September 25, 2020

**Re: Panoche Energy Center, LLC comments on UIC Permit No. R9UIC-CA1-FY17-2R**

**Figure 1**

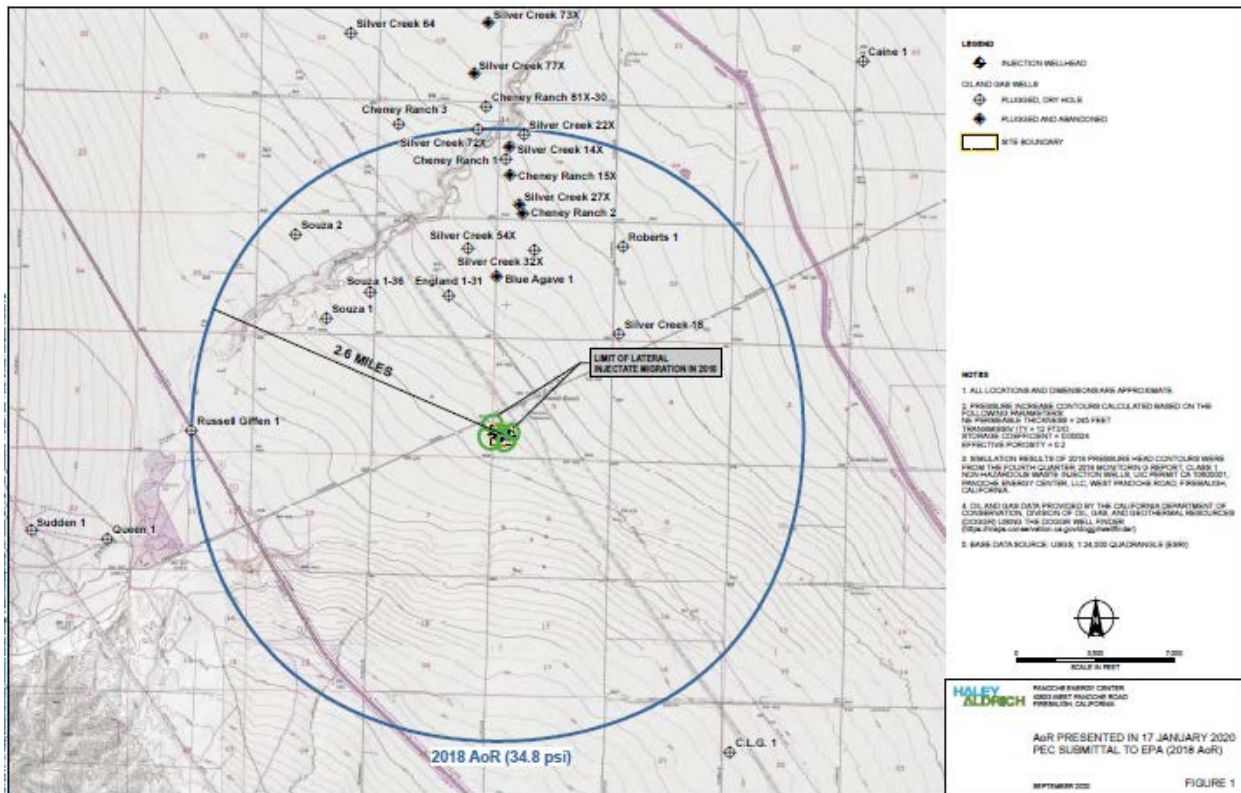
**Step 4.** The modeled distribution of a 34.8 psi increase in injection reservoir pressure was geographically rendered in Figure 1.

Figure 2

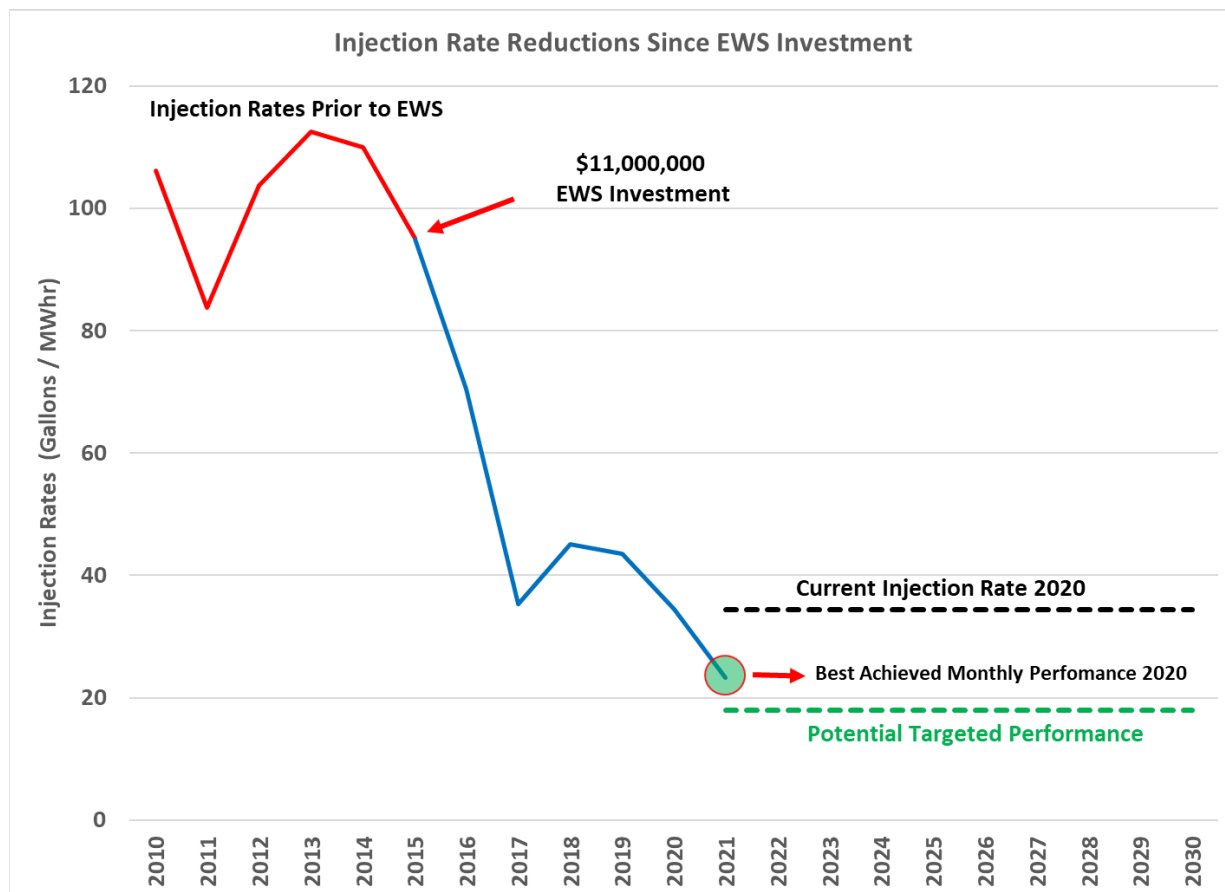
PEC's September 2020 Analysis for the EWS and reduced injection volumes (Figure 2) shows that the mud column hydrostatic pressures in Souza #2, Silver Creek #18 and England #1-31 (Figures 3, 4, and 5, respectively) have always been in excess of the maximum reservoir entry pressures. In addition, the EWS evaluation also shows that each well experienced its highest increase in reservoir pressure in 2017; and since then, induced pressure within the reservoir has and will continue to decrease, due to lower injection volumes, throughout the life of the permit. These improvements are a direct result of the EWS commissioning in 2016.

Prior to the EWS being commissioned, injection rates on a gallon per megawatt hour (“gal/MW hr”) were as high as 112 gal/MW hr. Since the EWS was commissioned, injection rates have decreased significantly. Year-to-date in 2020, injection rates have reduced by approximately 70% to 34 gal/MW hr. Through continued optimization the Facility has been able to achieve injection rates as low as 22 gal/MW hr. See Figure 2 below.

**Figure 3**

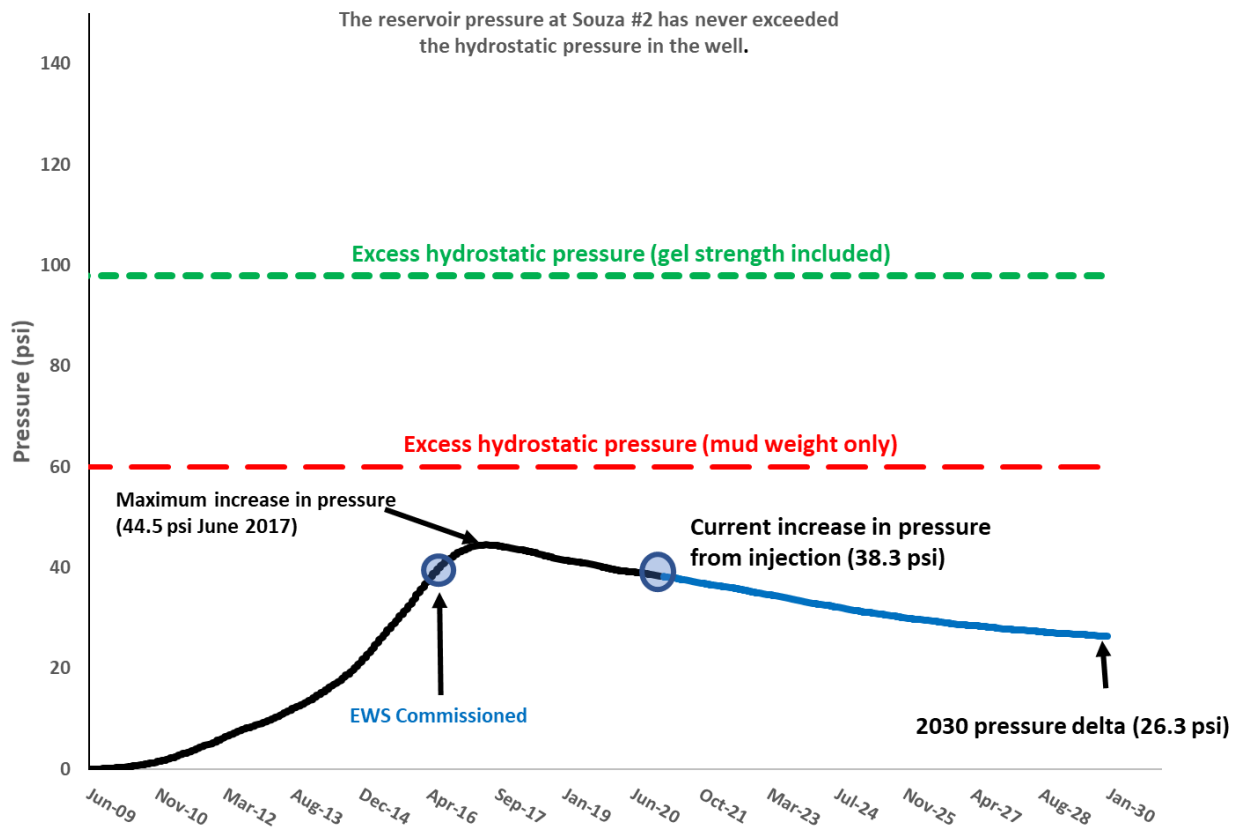
**Souza #2 Pressure History and Expected Future Pressure Decreases**

The reservoir pressure at Souza #2 has never exceeded the hydrostatic pressure in the well.

**Figure 4**

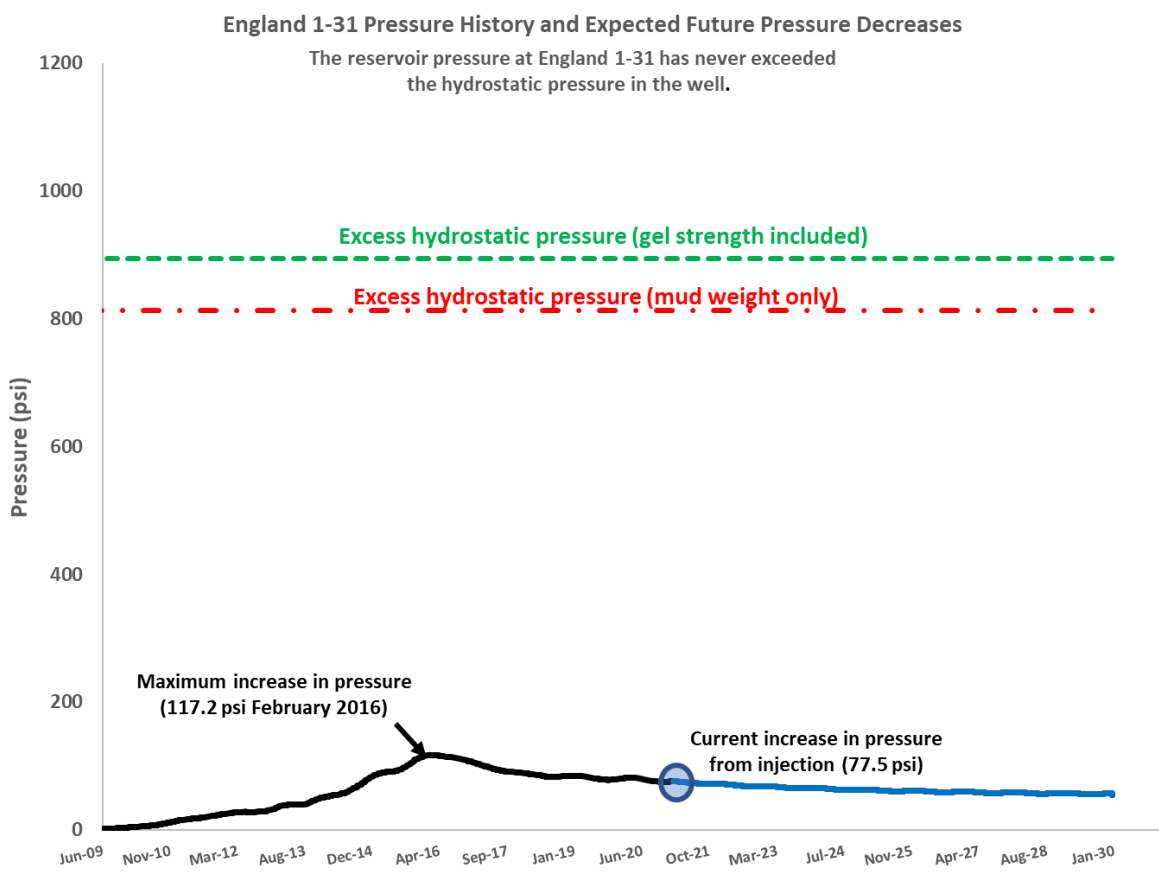
The hydrostatic pressures shown in Figures 3, 4, and 5 below represent the forces exerted on the injection reservoir from the mud weight in Souza #2, Silver Creek #18 and England #1-31 for the September 2020 Analysis compared to the modeled injection zone reservoir pressures.

Figure 6

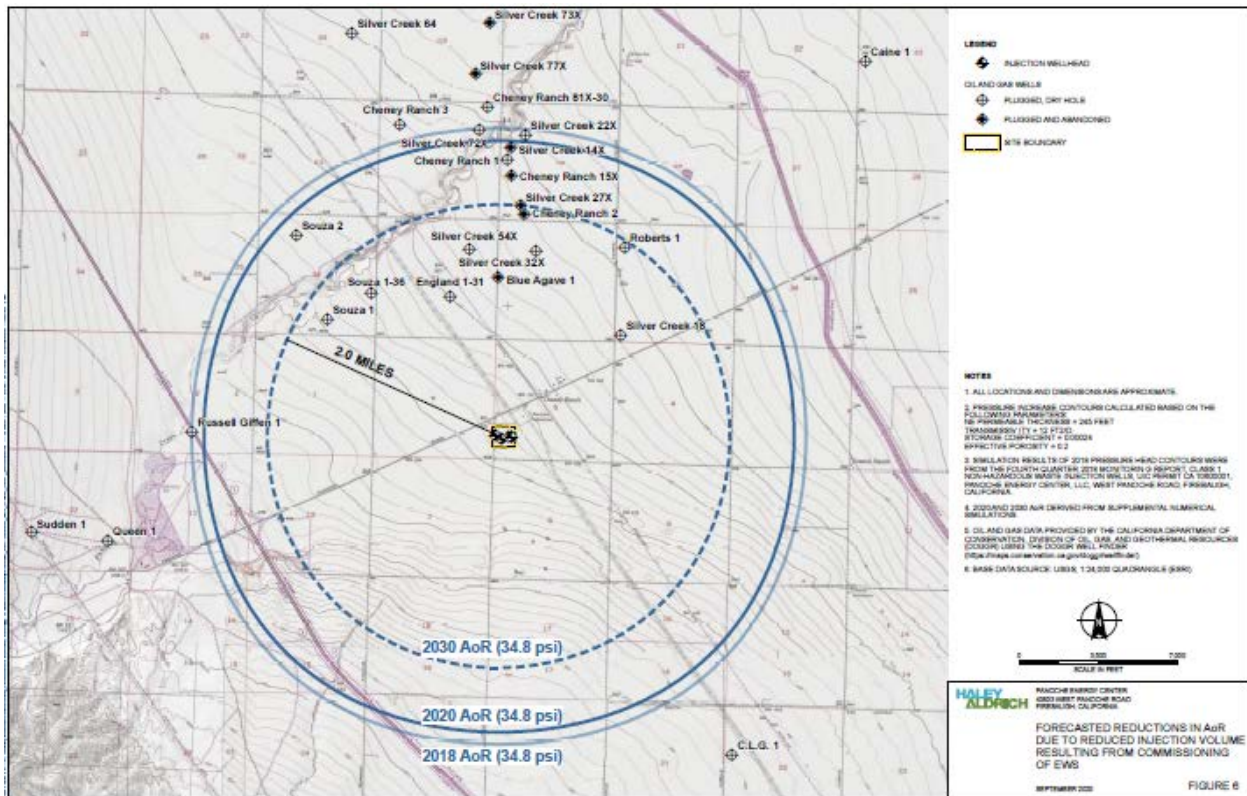
In addition, PEC has modeled how the EWS will reduce the AoR as a function of reduced injection volume over the life of the permit. As shown Figure 6 below, the AoR has contracted from 2018 to August 2020, and will continue to contract inward significantly by 2030.
